ADMINISTRATIVE AMENDMENT

**MINOR AMENDMENT TO SITE DEVELOPMENT PLAN
APPROVED PRIOR TO EFFECTIVE DATE OF IDO**

DRB PROJECT NO. 1011638

L&C TRANSPORT OFFICE AND SHOP
112 94th Street NW, Albuquerque, New Mexico 87121

1 Site Plan
1" = 20'-0"

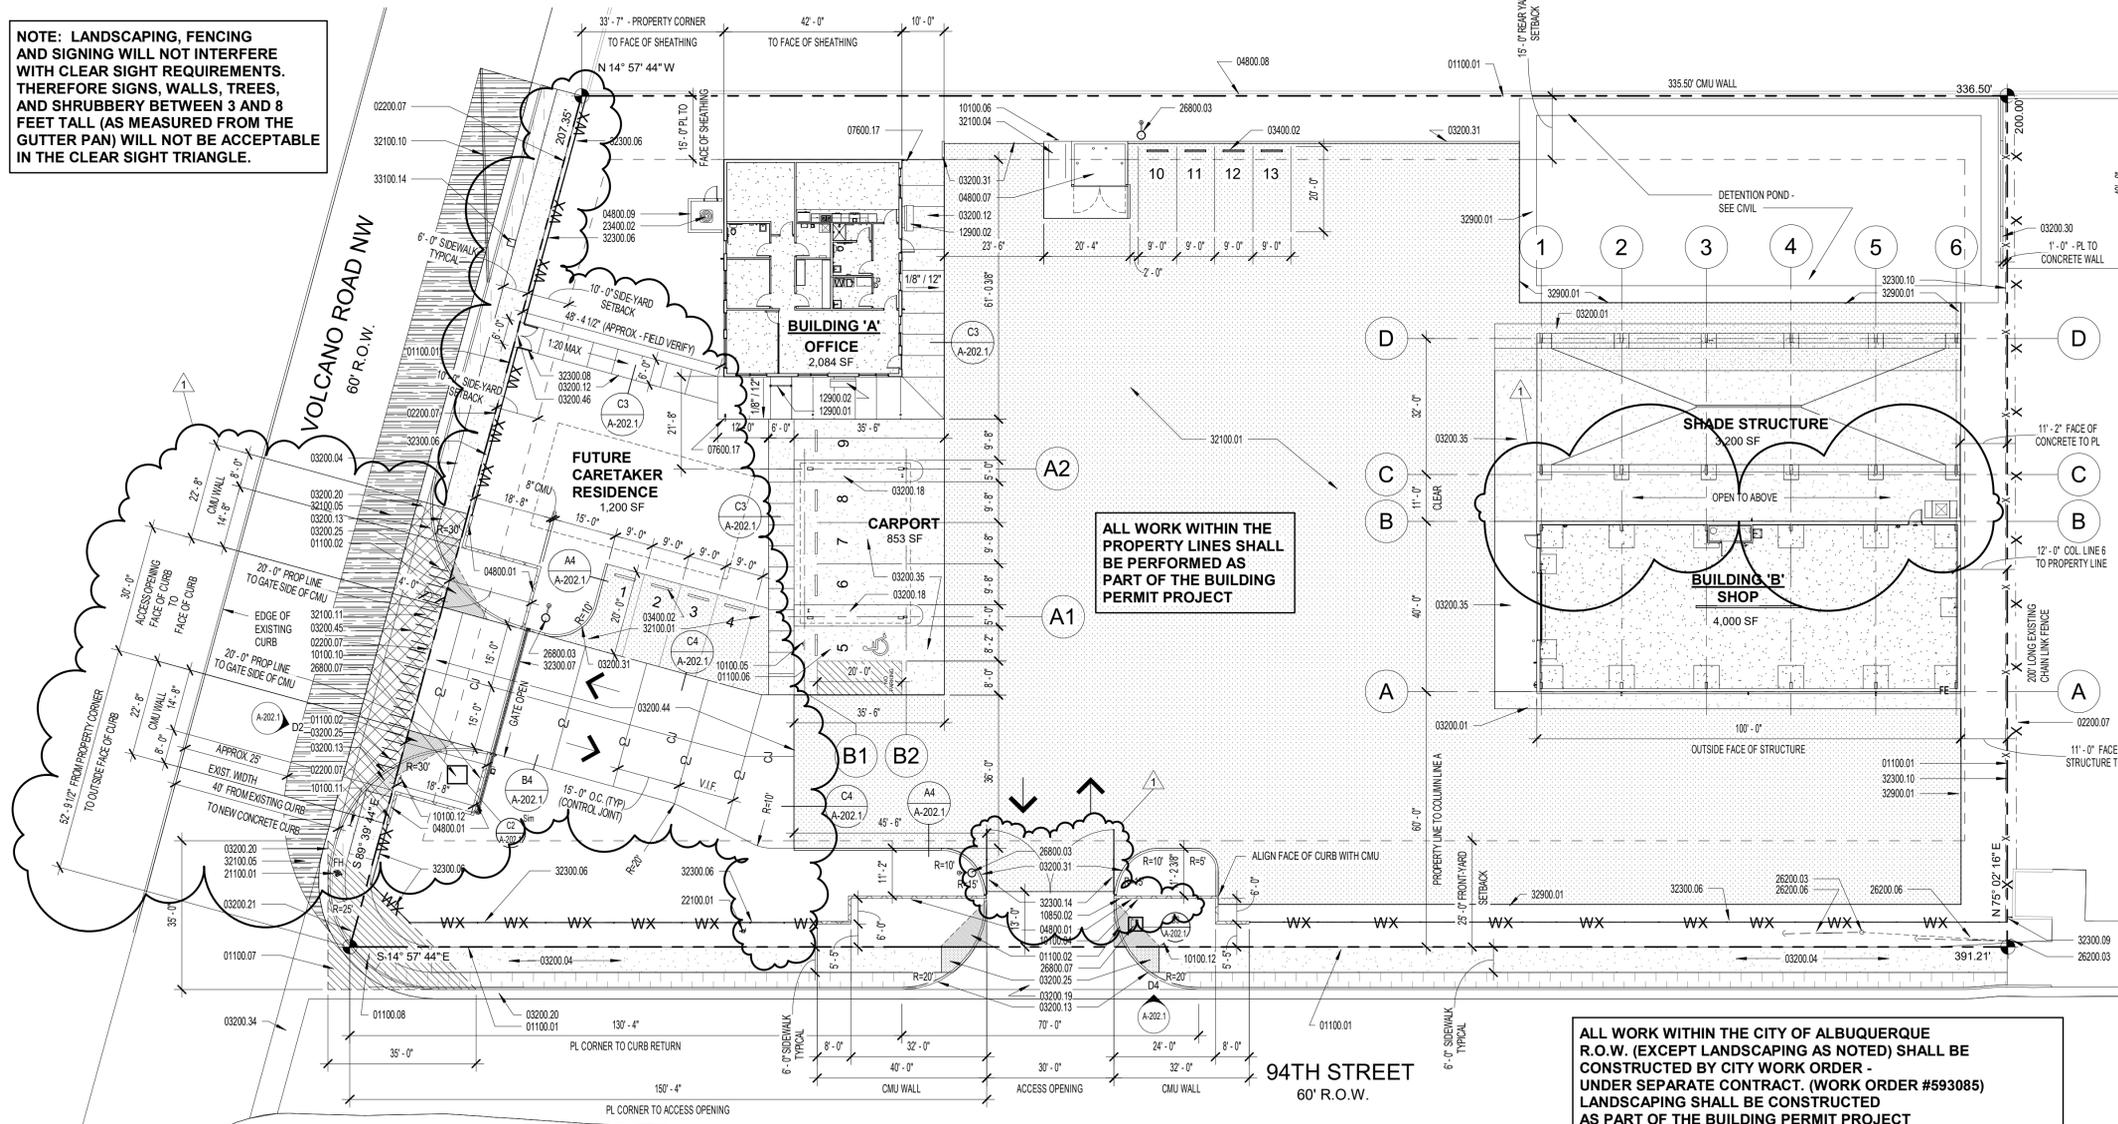
DESCRIPTION:
THIS MINOR AMENDMENT IS FOR THE CONSTRUCTION OF AN ADDITIONAL DRIVEWAY ENTRANCE INTO THE PROPERTY, RELOCATION OF THE PEDESTRIAN GATE AND SIDEWALK INTO THE PROPERTY, AND MINOR CHANGES TO THE LANDSCAPING TO ACCOMMODATE THE NEW DRIVEWAY.

- AN ADDITIONAL DRIVEWAY / CURB CUT WILL BE INSTALLED ON VOLCANO RD. NW. AN AUTOMATIC SLIDING GATE SHALL BE INSTALLED AT THAT ENTRANCE. THE ENTRANCE GATE ON 94TH ST. WILL BE A MANUAL SWING DOUBLE GATE.
- PEDESTRIAN ACCESS AND GATE WILL BE FROM VOLCANO RD. NW.
- ALL FENCING ALONG VOLCANO AND 94TH ST. WILL BE BROUGHT IRON. MASONRY WALLS WILL BE INSTALLED ON EACH SIDE OF THE VEHICLE GATES.
- FOUR INTERIOR PARKING SPACES WILL BE LOCATED NORTH OF THE HANDICAP PARKING SPACE.
- THE SHADE STRUCTURE IS A SEPARATE STRUCTURE FROM THE SHOP BUILDING PER THE APPROVED BUILDING PERMIT SET.

1 Landscape Plan
1" = 20'-0"

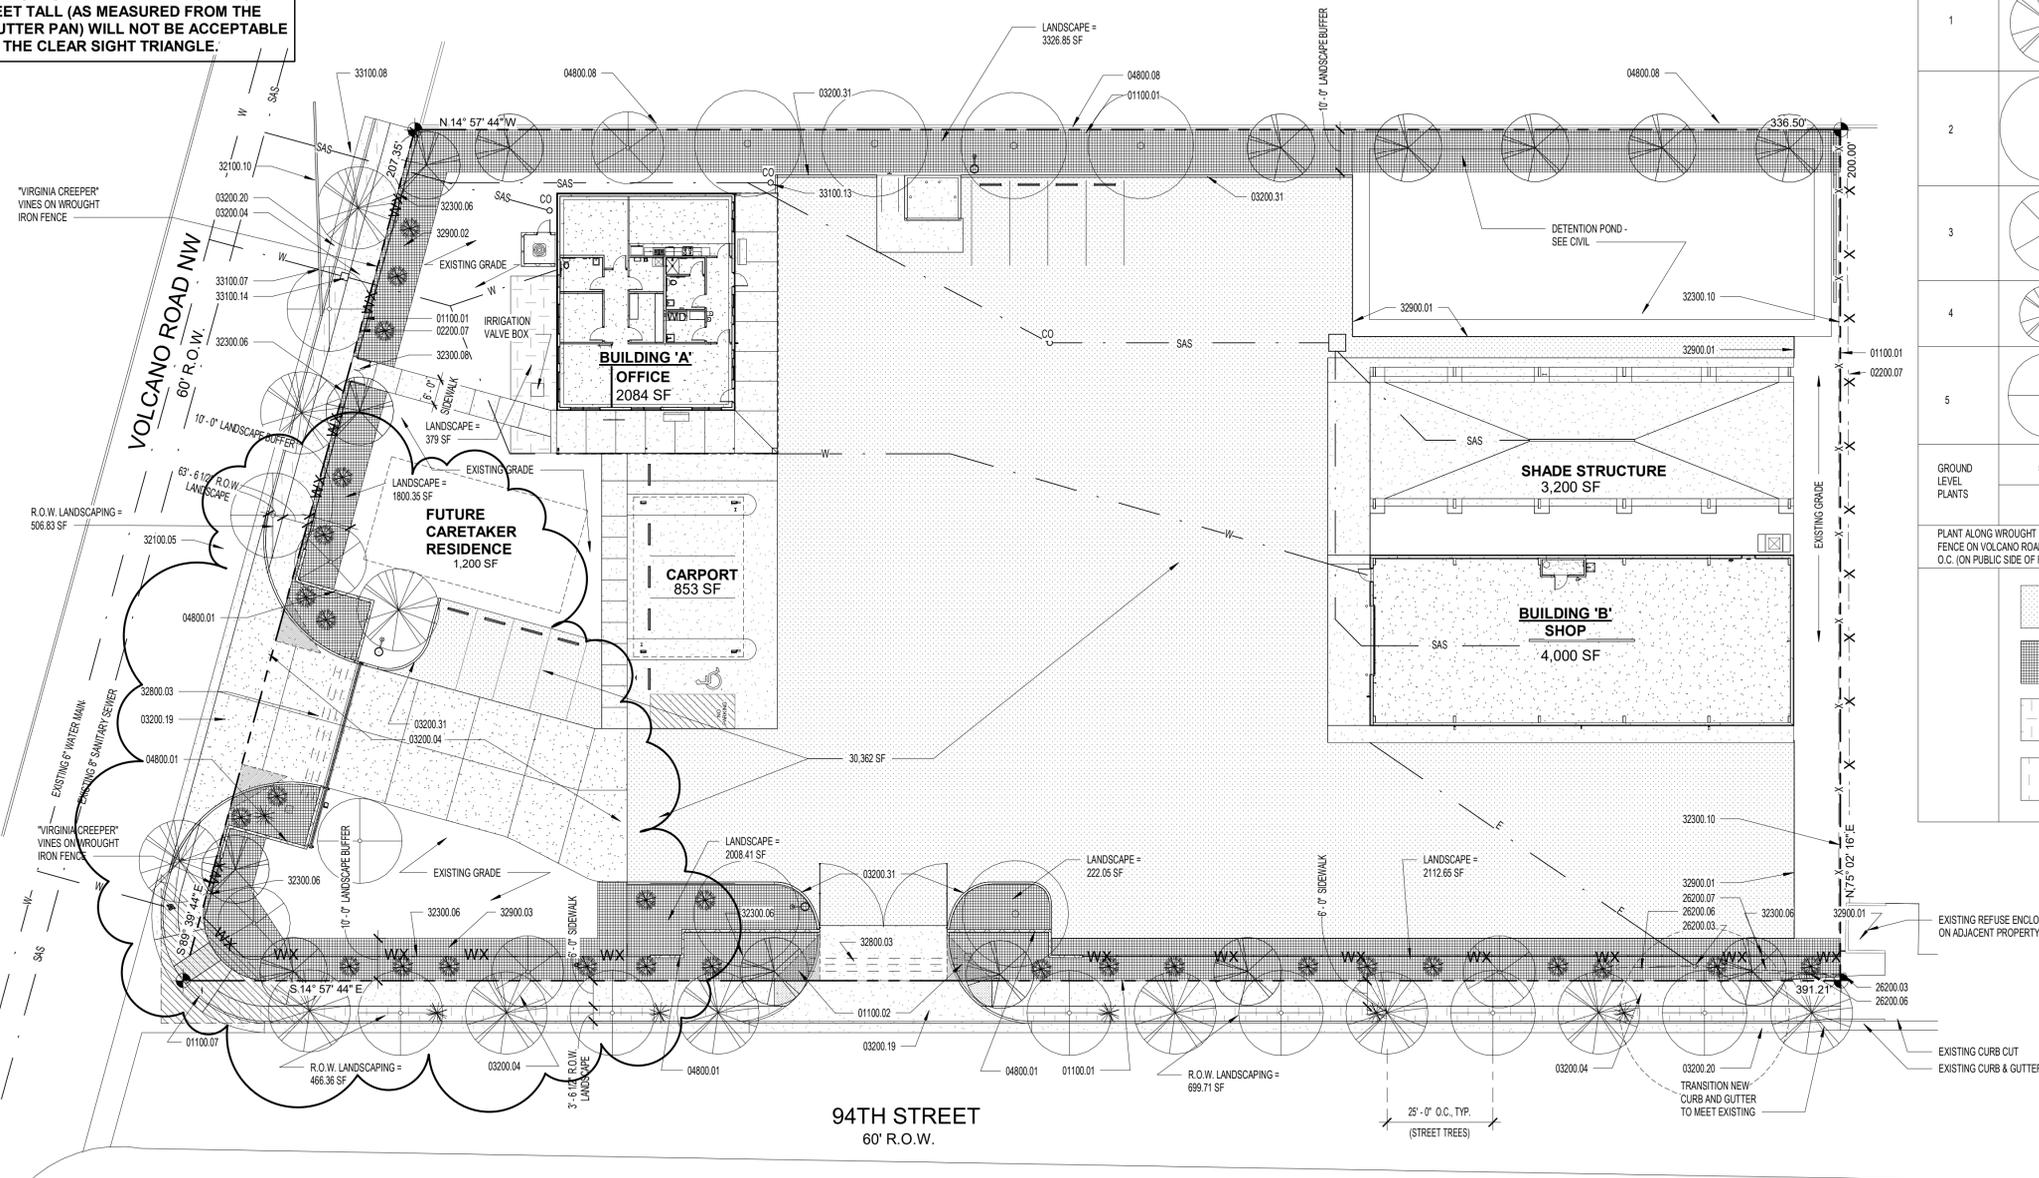
LANDSCAPE REQUIREMENTS PER MINOR AMENDMENT TO SITE PLAN / SITE PLAN AMENDMENT

PROJECT ARCHITECT: LEE GAMELSKY, AIA
MINOR AMENDMENT TO SITE PLAN / ADMINISTRATIVE AMENDMENT
SITE DEVELOPMENT PLAN FOR BUILDING PERMIT
DRB PROJECT NO.: 1011638
SITE DETAILS / SIGNAGE

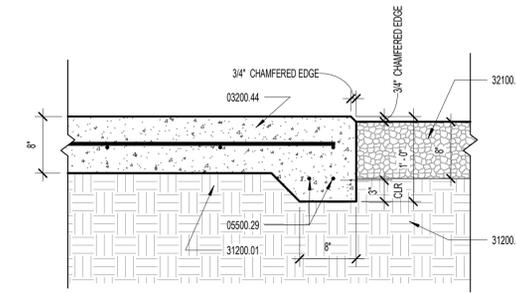
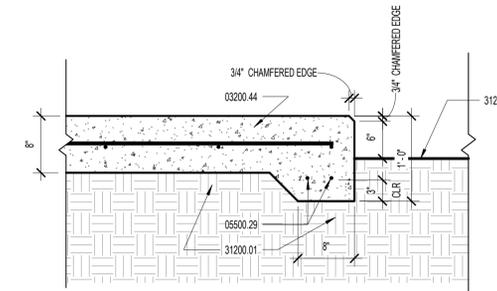
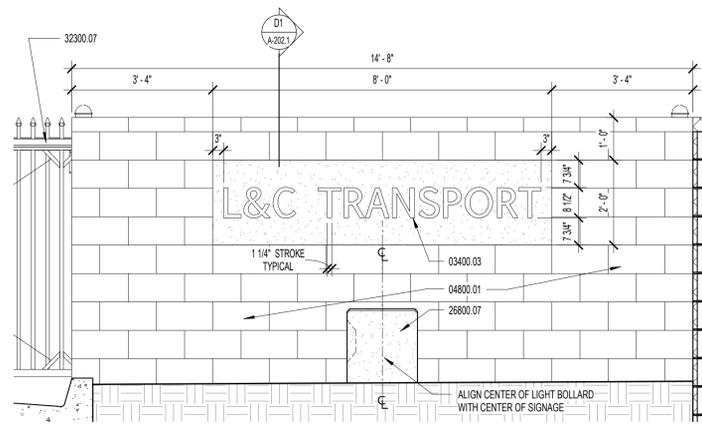
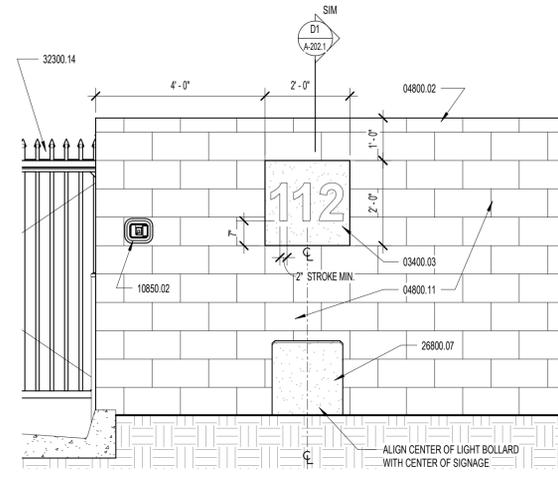
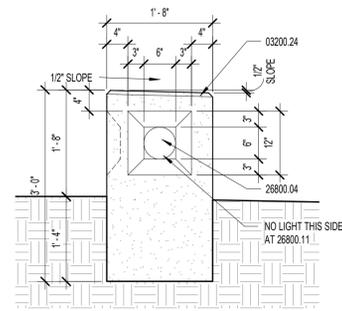
PROPOSED CHANGES PER THE MINOR AMENDMENT TO SITE DEVELOPMENT PLAN INDICATED BY THIS SHEET

1. NEW DETAILS FOR NEW CONCRETE DRIVE
2. REVISED PRE-CAST CONCRETE ADDRESS SIGN AND NUMBER.

PROJECT ARCHITECT: LEE GAMELSKY, AIA
MINOR AMENDMENT TO SITE PLAN / ADMINISTRATIVE AMENDMENT
SITE DEVELOPMENT PLAN FOR BUILDING PERMIT
DRB PROJECT NO.: 1011638
BUILDING ELEVATIONS - SHOP / SHADE STRUCTURE

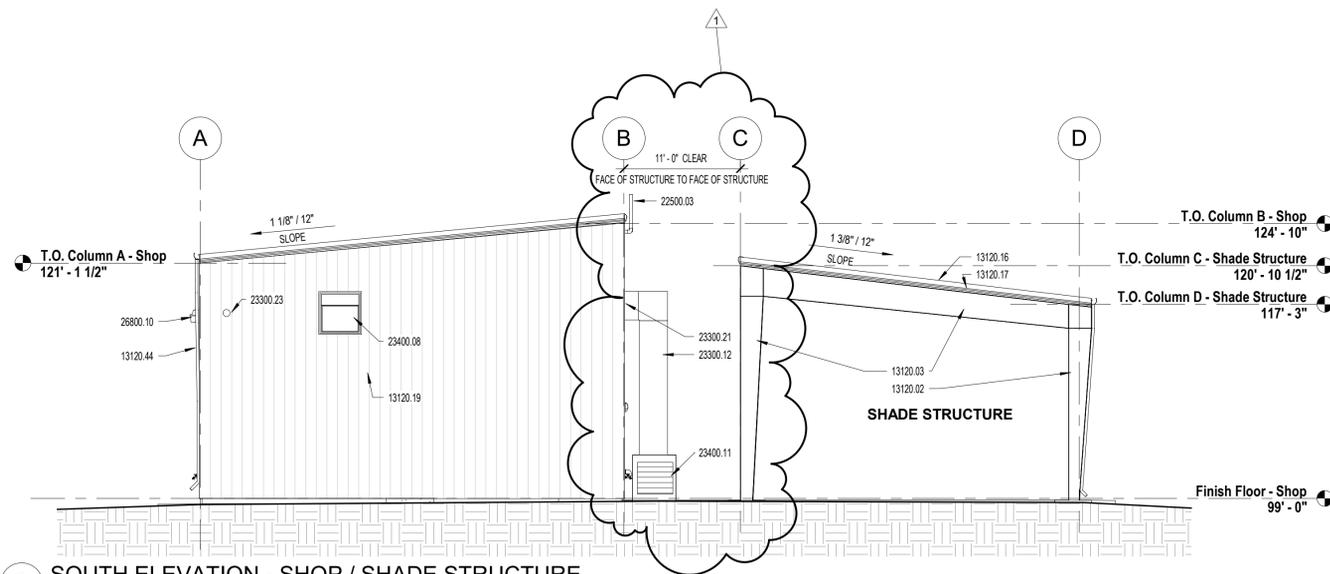
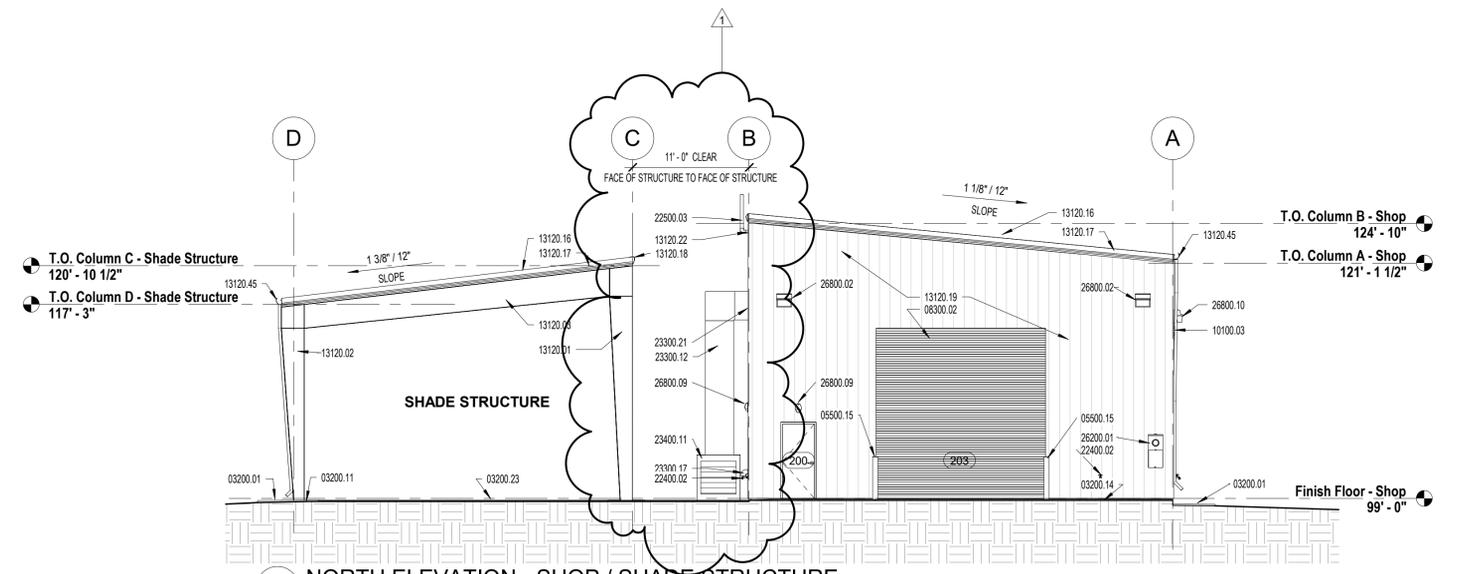
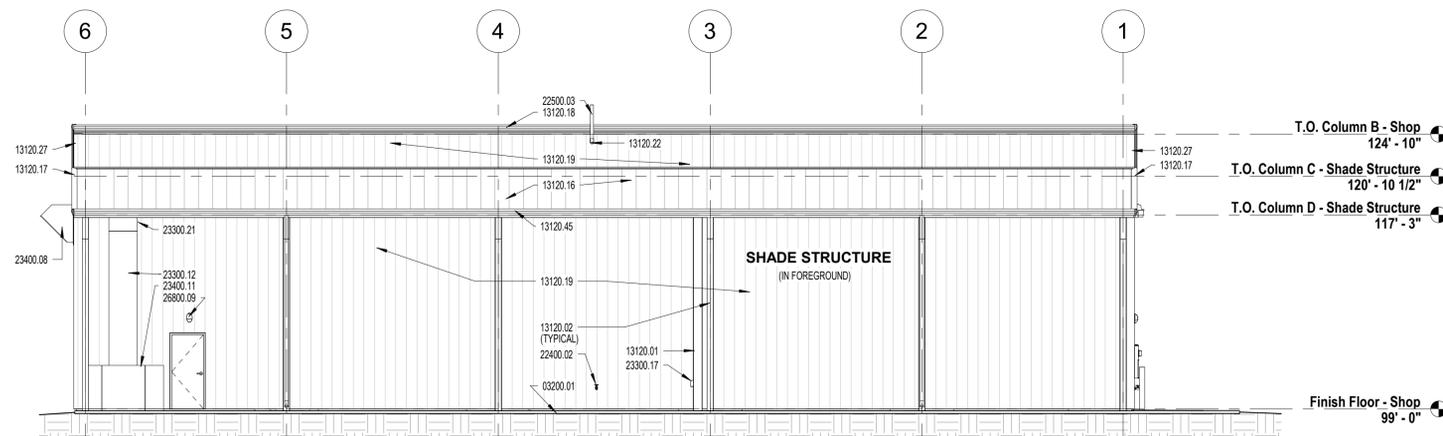
PROPOSED CHANGES PER THE MINOR AMENDMENT TO SITE DEVELOPMENT PLAN INDICATED BY THIS SHEET

- 1. THE SHADE STRUCTURE IS A SEPARATE STRUCTURE FROM THE SHOP BUILDING PER THE APPROVED BUILDING PERMIT SET.
